ASSESSMENT REPORT

NRE No. 1 Mine – Preliminary Works Project Modification 1 – Longwalls 4 and 5, and Gateroads 6, 7 and 8

Figure 2: Proposed Modification

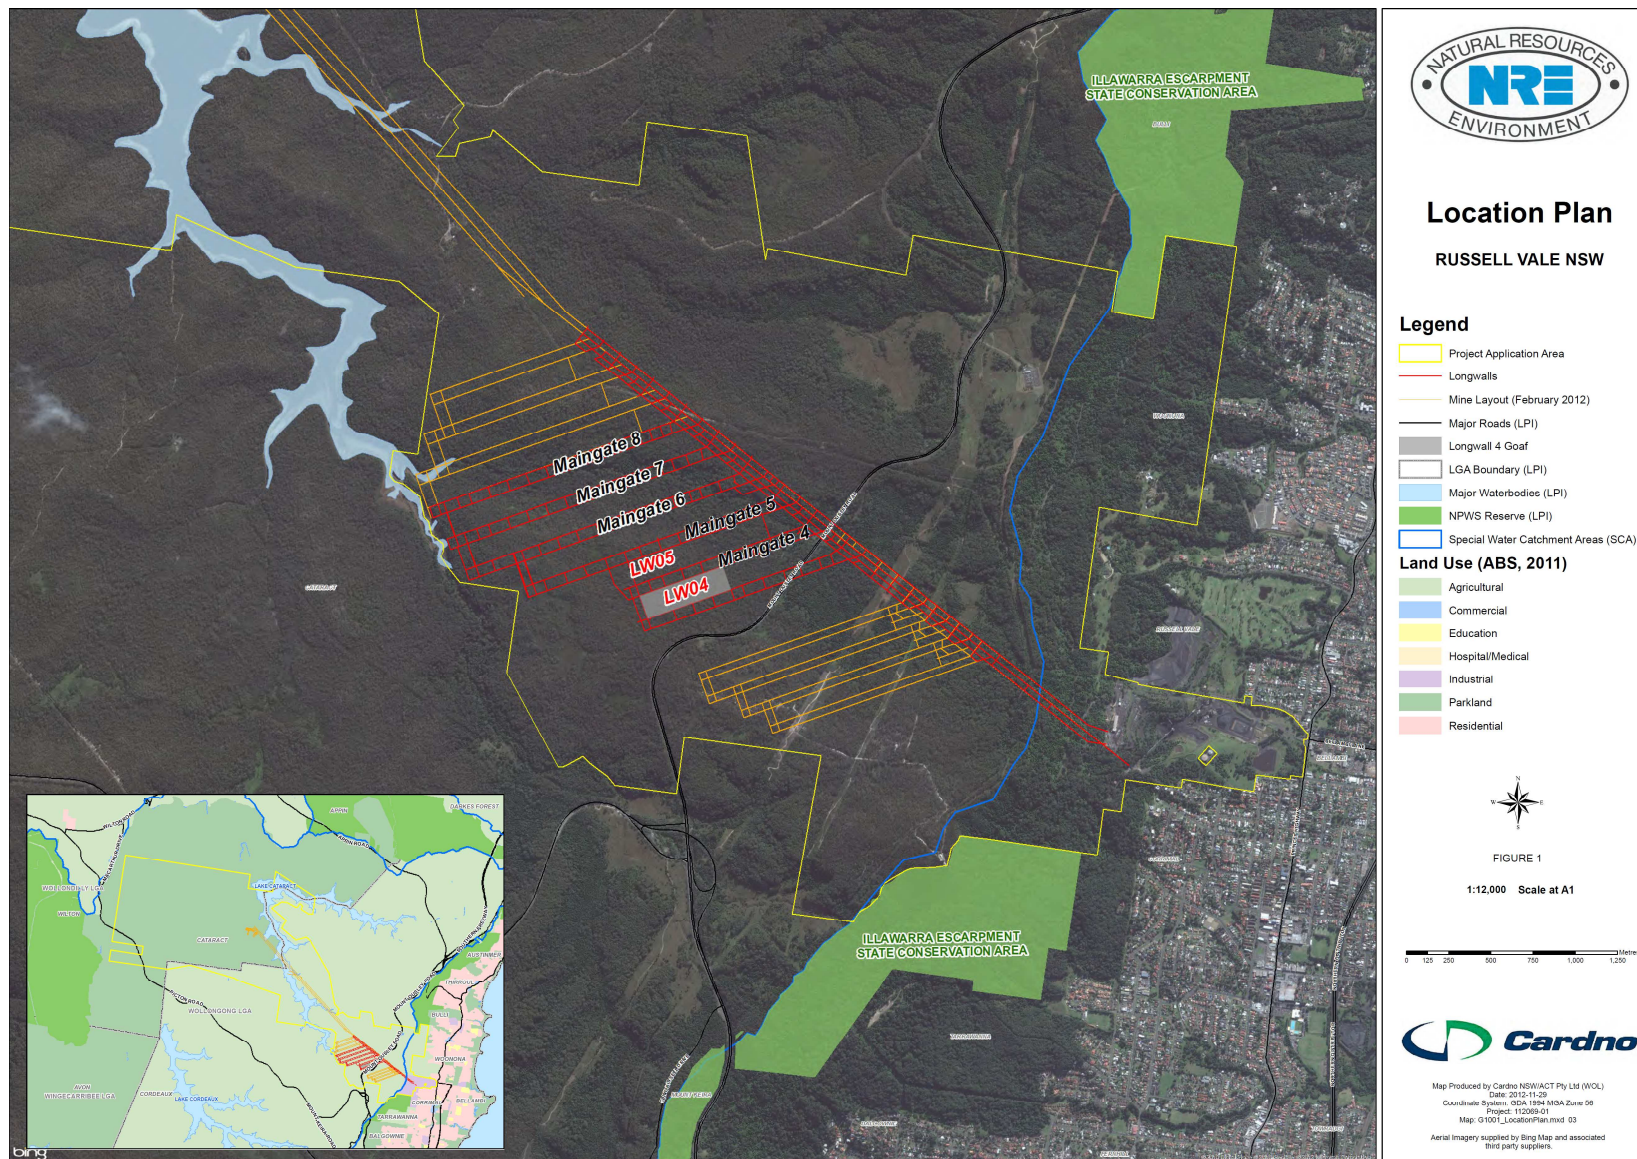
In response to concerns raised in submissions, the proposed Longwall 5 has also been significantly reduced in length from an initial 1,145 m to approximately 845 m.

Maingates 6, 7 and 8 are three sets of twinned underground development headings located to the northwest of Longwalls 4 and 5 which have the primary purpose of forming 'gateroads' to outline the next three proposed longwall blocks, ie Longwalls 6, 7 and 8 (see **Figure 2**).

SCA has residual concerns about the proposed development of the maingates as it believes that significant impacts may result from future longwall mining in this area. The Department understands that there are features of special significance located over these gateroads, including Cataract Creek and upland swamps CCUS4 and CCUS5. A future proposal to conduct longwall mining in this area may have adverse impacts on these features. However, no detailed information (for example a subsidence impact assessment) is before the Department to enable it to come to a firm, substantive and reasonable position on whether or not extraction of these longwalls can be undertaken with acceptable environmental impacts, or not. Any future application would be subject to a separate, rigorous assessment and would be informed by the experience of mining Longwall 5. Gujarat has also made it clear to the Department that the development of these gateroads would be at its own financial risk.

Figure 5 – Subsidence Measured on South and North Cross Sections above Longwall 4

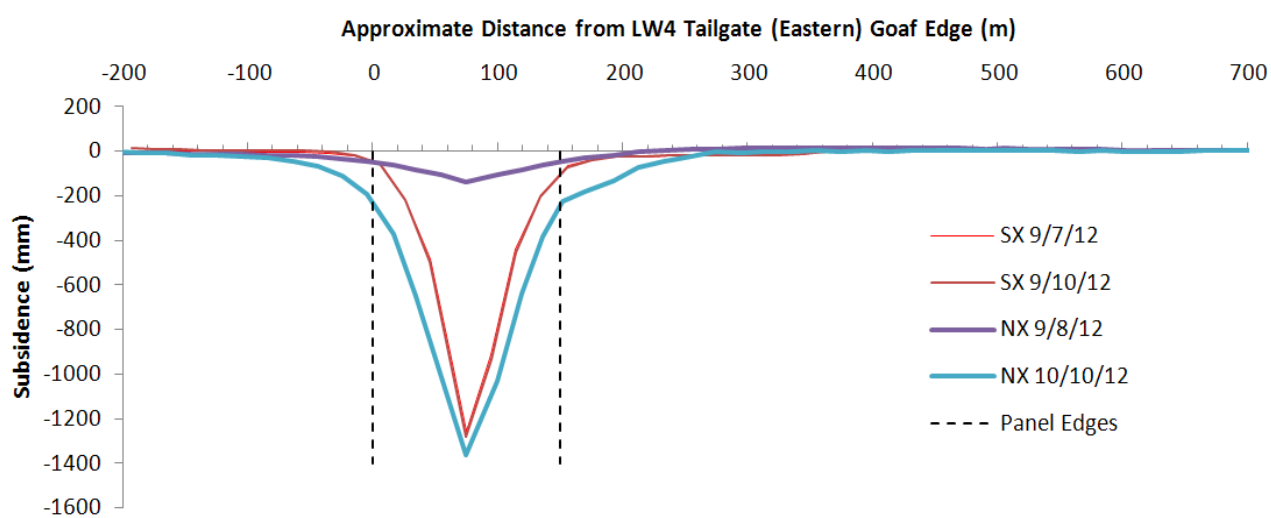
The great majority of Cataract Creek is located more than 200 m from any point above the proposed Longwall 5 extraction void. However, the proposed finishing line of the longwall is only about 40 m distant from the Creek. Given this relative proximity, the Department acknowledges that there is some risk of subsidence impacts, particularly from tensile strains. However, vertical subsidence in Longwall 4 was predominantly constrained to within the limits of the longwall void and the strains were largely confined to the inside edge of the chain pillars as shown in **Figure 5** above.

Figure 7 – Pressure Profile Measured in Longwall 4 Borehole (GW01)

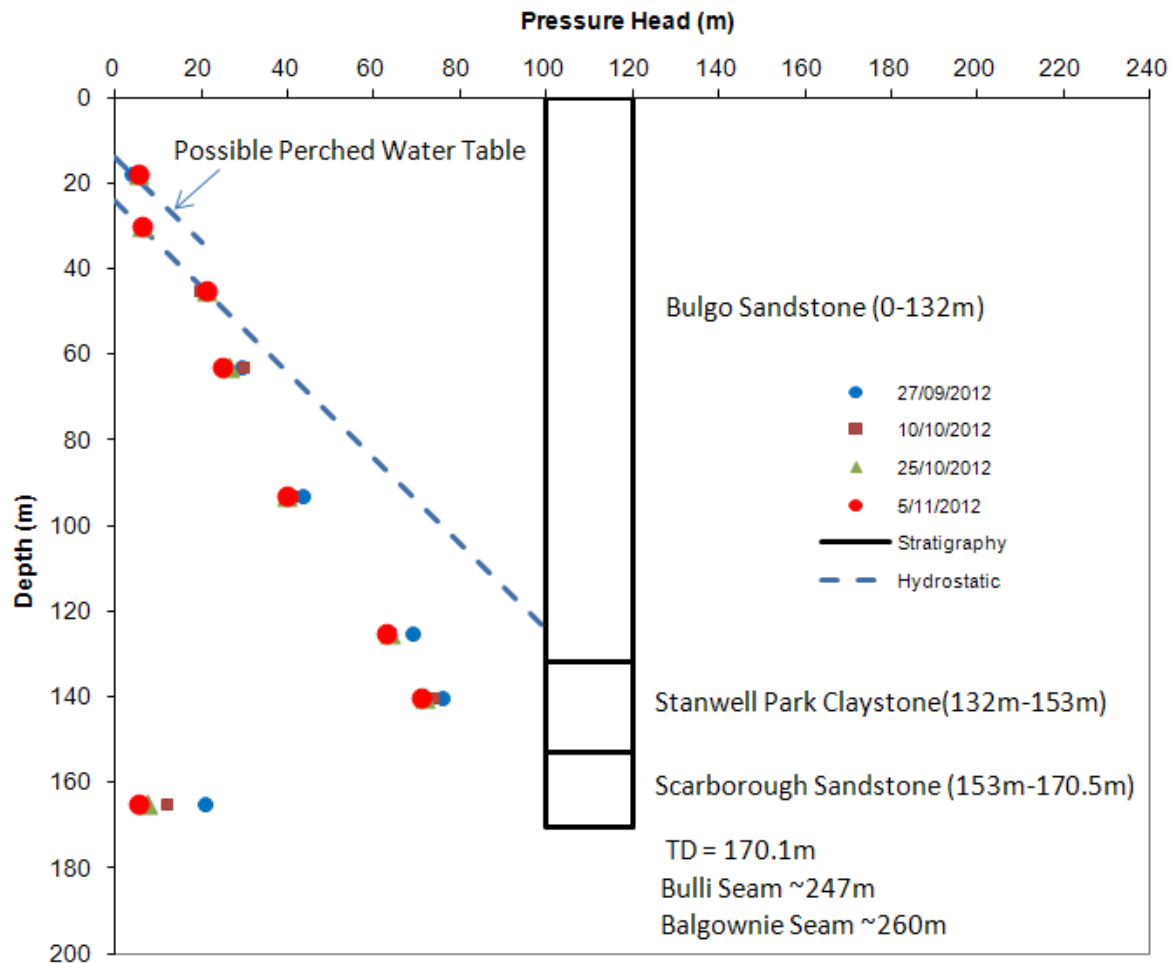
There is no potential for significant flow from the stored waters into the mine. An increase in vertical hydraulic conductivity is expected in areas that have been directly undermined, as evidenced by the piezometric profile shown in **Figure 7** below, but the magnitude of flow is likely to be insignificant by comparison with the volume of rainfall recharge and other natural effects such as evaporation from the surface of the reservoir.

Using data obtained from GW01, SCT has plotted a hydrostatic pressure gradient from 24 m below the surface, the elevation of the current standing water level in the bore (see **Figure 7** below). A hydrostatic pressure gradient represents the rate of increase in water pressure that would be expected in a connected body of water where there is no vertical flow, such as might be observed in the ocean for instance.
